Crown Pastoral Land Tenure Review

Lease name: LONG GULLY

Public Submissions - Part 3

Submission on Tenure Review Proposal for Long Gully Pastoral Lease, Po 55

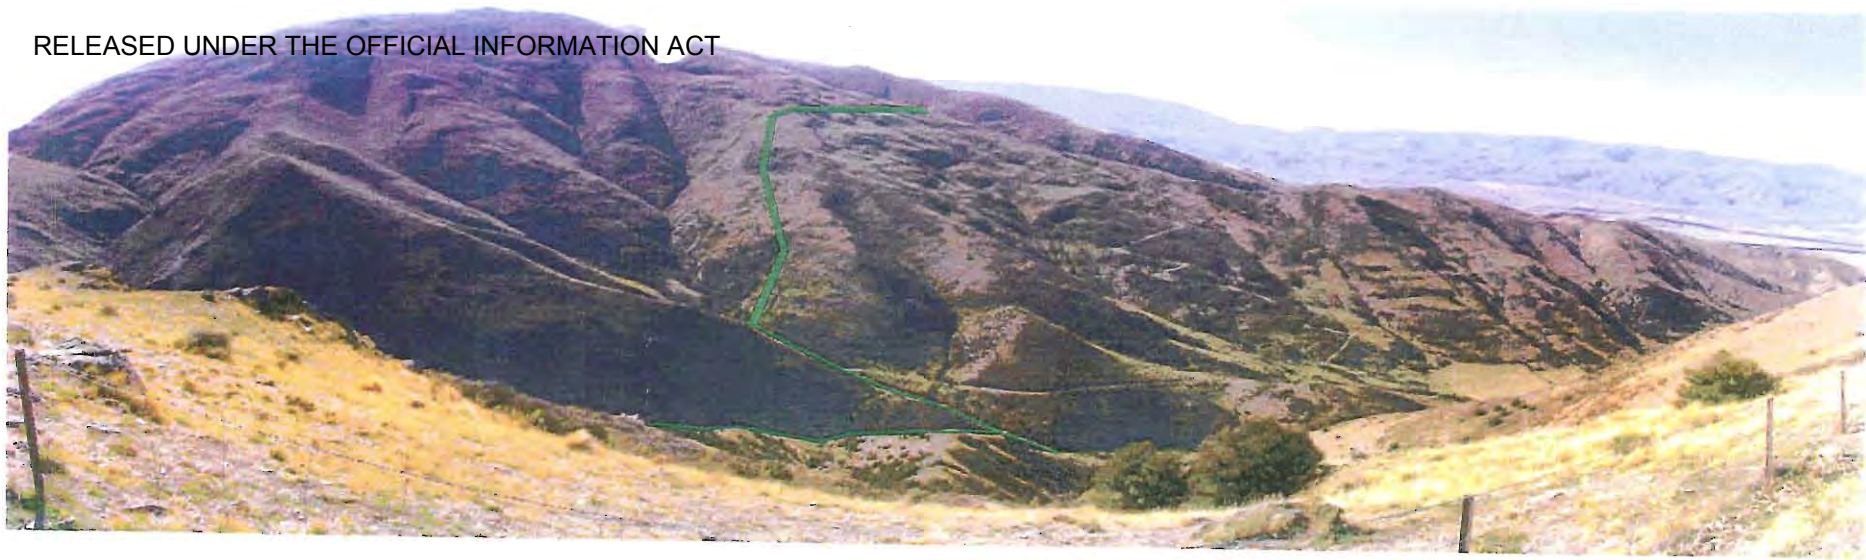
The head of this gully rises to nearly 1200m asl and there is snow tussock cover extending down to below 900m, due to a cooler southerly aspect. We also observed a lot of regenerating and remnant shrubland throughout the gully, mainly patches of kanuka and 'grey' scrub (matagouri, coprosma, olearia, broom, etc) (see *Photo 1*). We recognise that fertiliser application would have encouraged some of the growth but much of it will reflect a natural return of woody cover with cessation of burning and perhaps more conservative grazing as well as limits on rabbit numbers. We are very aware of the high values now being placed on remnant low altitude grasslands and shrublands, even modified ones, as ecosystems almost absent from our range of protected areas. We understand that they are very important for a rich insect and bird fauna and are highly characteristic of Central Otago's pre-European and even pre-human condition. At the same time they are highly vulnerable to loss through land development. There is a high imperative to protect and provide conditions for recovery of woody cover over what has previously been regarded as 'ordinary' farmland with 'scrub'.

Overall the gully has a natural character although clearly modified by pastoral practices and scarred by tracking. We note that the landscape survey did not identify any of Long Gully as having significant landscape values. This is because emphasis was placed on visibility from public roads, rather than the inherent aesthetic values of the natural landscape (which in our view are high over the upper head basin, as part of the range crest landscape).

Photo 3. Clutha Faces - View of the Long Gully Clutha faces from SH6 Luggate-Cromwell. The relative naturalness of the faces is important and the widespread shrublands make an important contribution to their character and natural appearance.

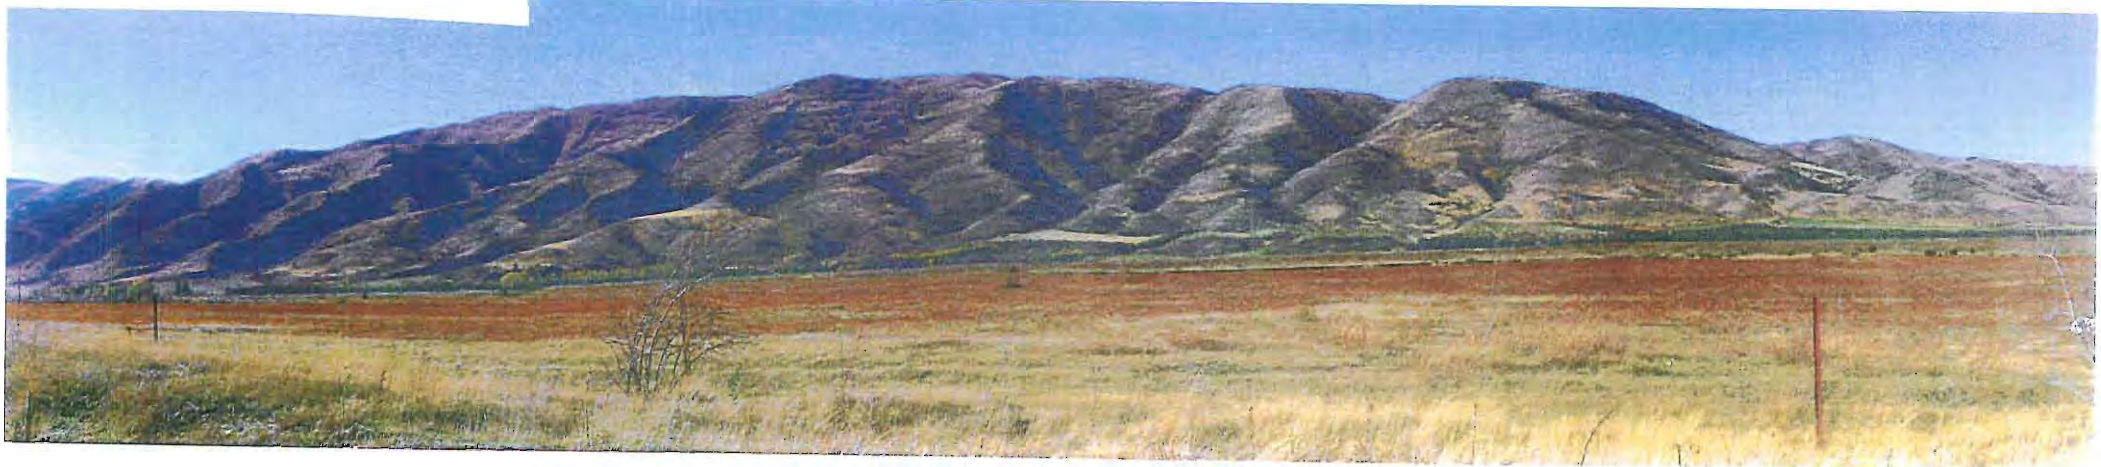
As with Long Gully, there are extensive native shrublands regenerating over these faces, which also have particularly high visual significance overlooking two state highways and a major river corridor (see *Photo 3*). The native shrublands contribute significantly to the natural character and have a major role to play in defining the 'place' of this part of the Upper Clutha. Total clearance of the cover is currently permissible under the District Plan. This would detract seriously from the landscape values as well as being unacceptable from an ecosystem perspective given that only a very small percentage of these communities are currently protected. Other activities such as tracking, fence lines and tree planting could have adverse effects on the values. A covenant for landscape protection purposes is recommended including a Shrubland Management Plan as detailed for Llong Gully.

Our submission is that the faces can be freehold but with a landscape covenant over the majority of the area and the shrubland is to be substantially protected especially kanuka and broom and mixed coprosma-matagouri-olearia shrubland. We have outlined two ways to achieve this as above.

Fig. 1 Recommended Conservation Area on Long Gully Pastoral Lease
submission of Central Otago-Lakes Branch Forest and Bird
May 2009

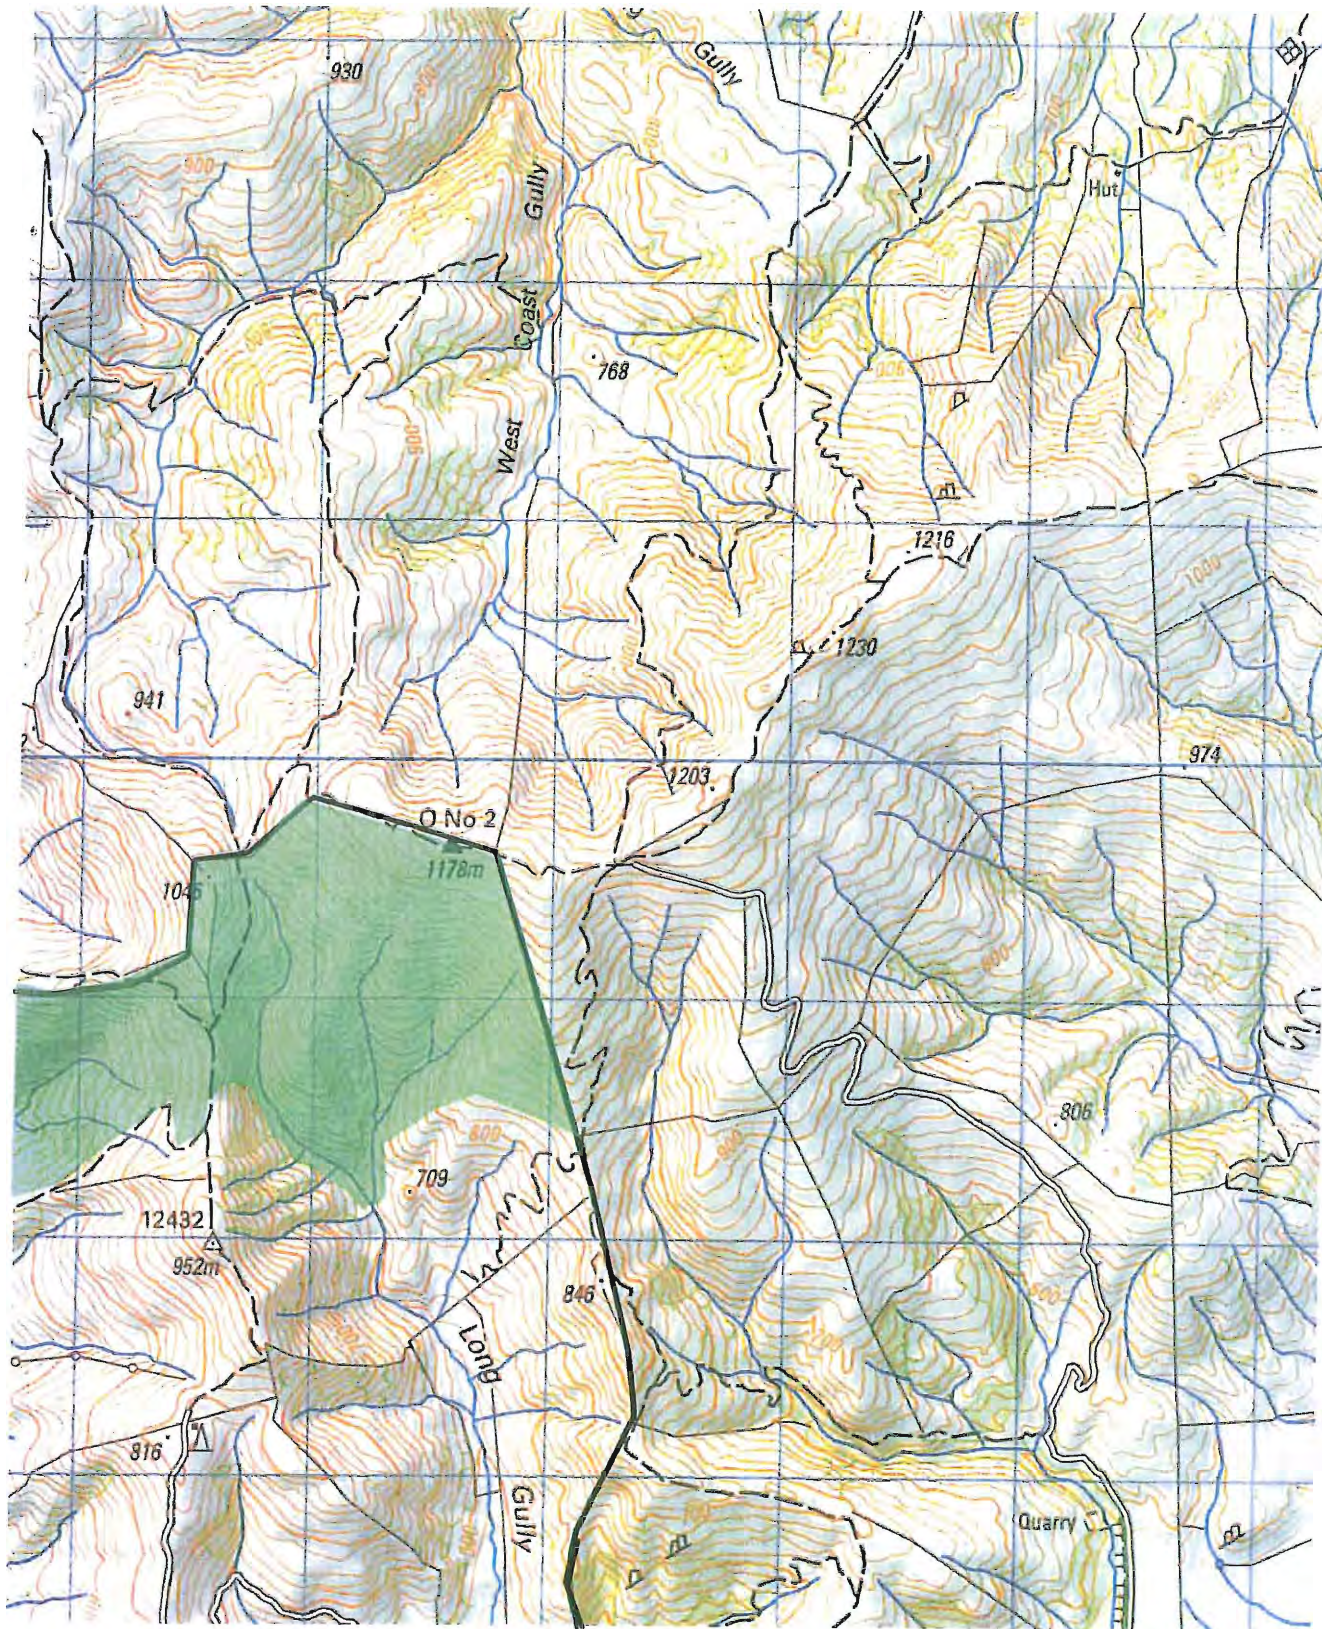
We are concerned however that allowing continued grazing over the higher part of the valley will lead to the eventual demise of the snow tussock. Fertiliser is not economic to apply over this higher country as the returns through pasture growth and production are too low. Fertiliser if it is applied can also promote the dominance of exotic species which would contribute to the decline of snow tussock. This is likely to especially occur at the lower margins. The presence of snow tussock below approximately 1000m is increasingly rare and we would not like to see the area of snow tussock in Long Gully shrink.

The proposed covenant does not allow for free public access over the range crest which is likely to be desired, and exercised in reality.

The retention of the upper head basin as conservation land would also compliment the CA2 area, if it was continuous with it.

We submit that the gully head should be retained as conservation land with free public access, and that grazing cease. The area we would like to see retained is shown on Fig 1 attached. A grazing licence could be issued subject to strict limits on stocking, robust monitoring conditions and ability to require cessation or changes to grazing.

Should the final outcome be the proposed covenant, as a second best option, We submit that the area covered by the covenant is that we have outlined on our Fig. 1. There will need to be conditions restricting the number and timing of stocking so that the stress on the snow tussock is minimal and able to be recovered from, and there will need to be robust monitoring provisions with ability to require amendment to or cessation of all grazing.

Fig. 2
Recommended Location
of 'g' on SH8A

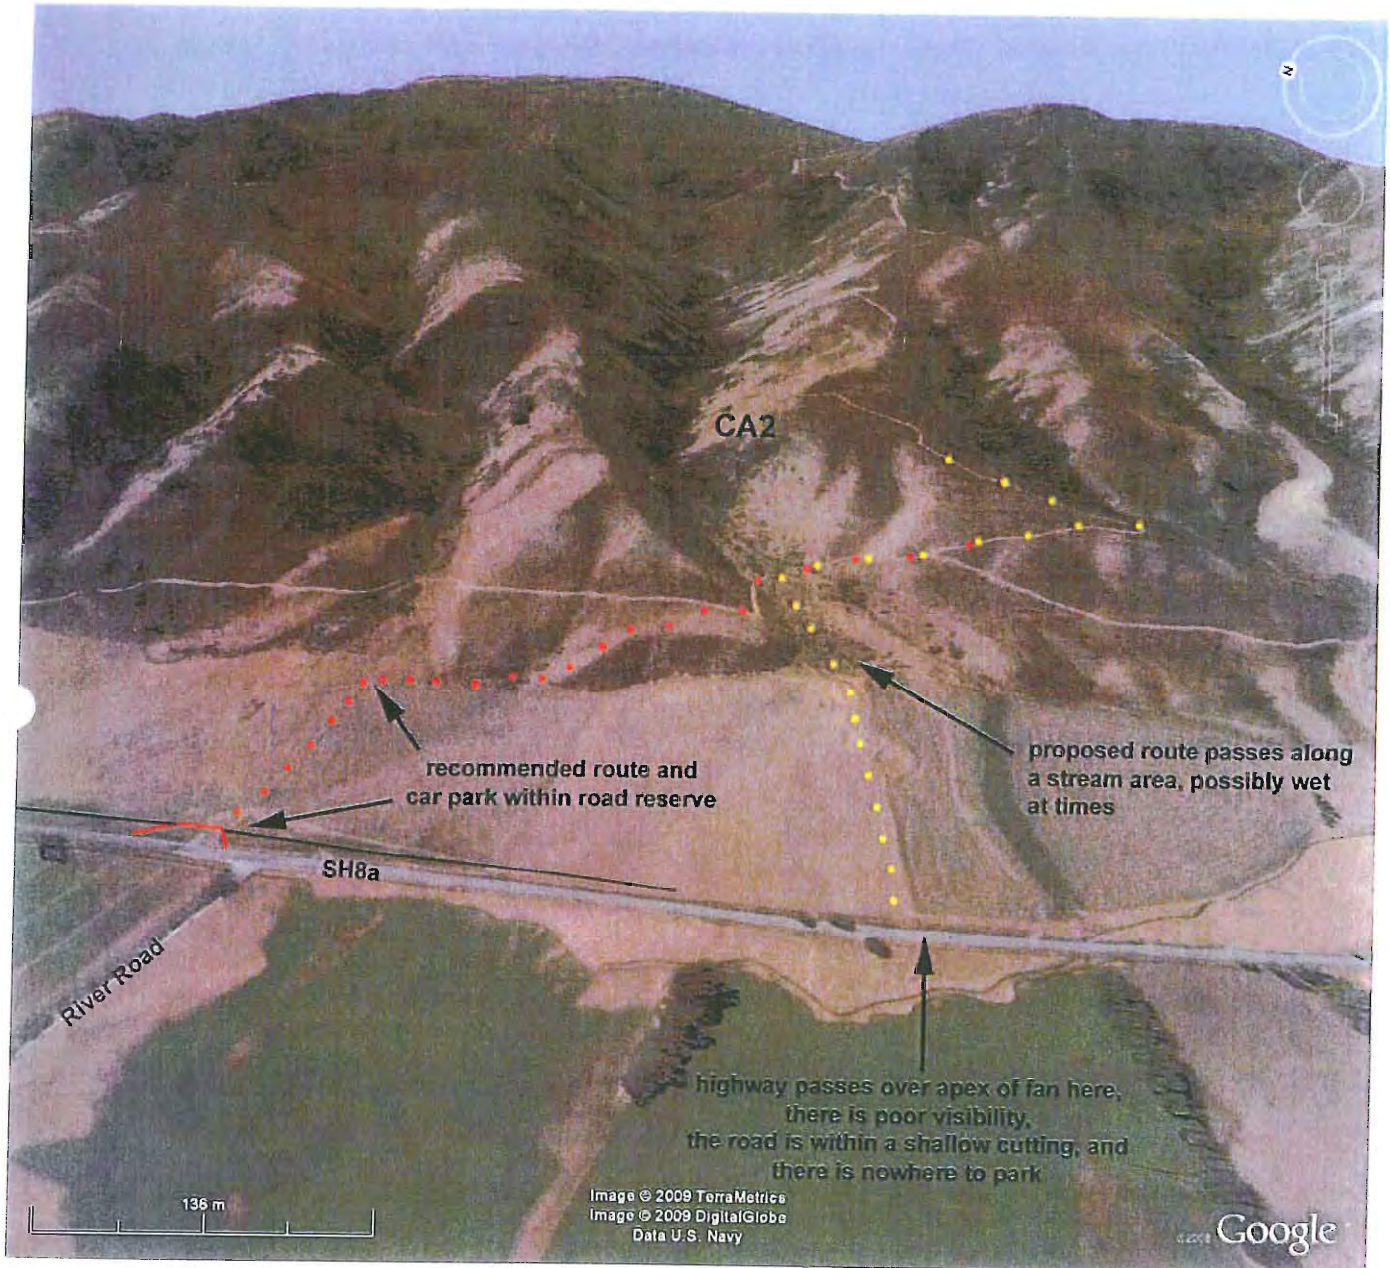
The location of 'g' is on a slight crest of the highway with limited visibility of traffic and there is nowhere to park. A bank edges the road. The route up to the 4WD track appears to follow a stream course and may involve crossing at least seasonally wet areas. It does not seem to us to be the best place to access Long Gully.

We suggest an access point further north, in the vicinity of the River Road junction. This is a long flat stretch of road with good visibility; there is room to pull off; and the access on to the property is flat, through an existing gate. In fact, it appears that the road reserve is partly comprised of the paddock, which means there may be room to create a small car park here. The paddock can then be crossed to its upper edge and a quick walk up the dry relict terrace riser gets one to the 4WD track. Our recommendation is shown in Fig. 2 attached.
